INTERNAL MEMORANDUM

OBSERVATIONS BY THE ENGINEERING AND HIGHWAYS DIVISION IN RESPECT OF DEVELOPMENT AFFECTING EXISTING OR PROPOSED PUBLICLY MAINTAINED HIGHWAY

The proposed application is for the conversion of a former chapel into five residential units, demolition of rear vestry and the creation of car parking area.

Bethel Chapel, John Street, Treharris, Merthyr Tydfil, CF46 5PS

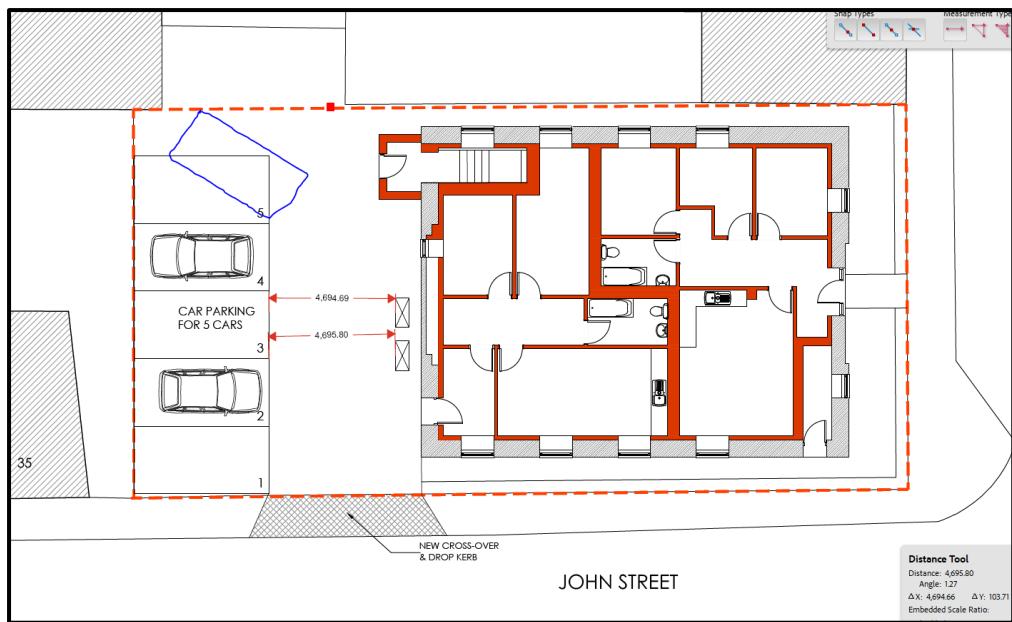
There was already an under provision for parking for the existing chapel, the extant use of the site. As per the submitted plan, **Proposed Site 24-112 P07** there are 5no proposed parking spaces provided which is an under provision, however the highway authority deem this acceptable for the proposed 5no residential units as the parking facilities are not being made worse than the extant use of the site.

As per the Welsh Parking Standards 2014, any proposed car parking spaces should be 2.4m in width x 4.8m in length, therefore the proposed 2.5m x 5m parking bays are acceptable in terms of size.

As per the Welsh parking standards a 6m manoeuvring area should be provided in front of each space. Due to the existing heat pumps on the site this 6m manoeuvring area cannot be achieved at space no3, however by shortening all the parking bays to 4.8m this would increase the manoeuvring area, which would be accepted by the highway authority

Vehicles are unable to access parking space No5 as there is only a 4.0m manoeuvring area due to the rear entrance of the building, the applicant should resubmit a plan showing the alteration of space no5 as shown in blue below.
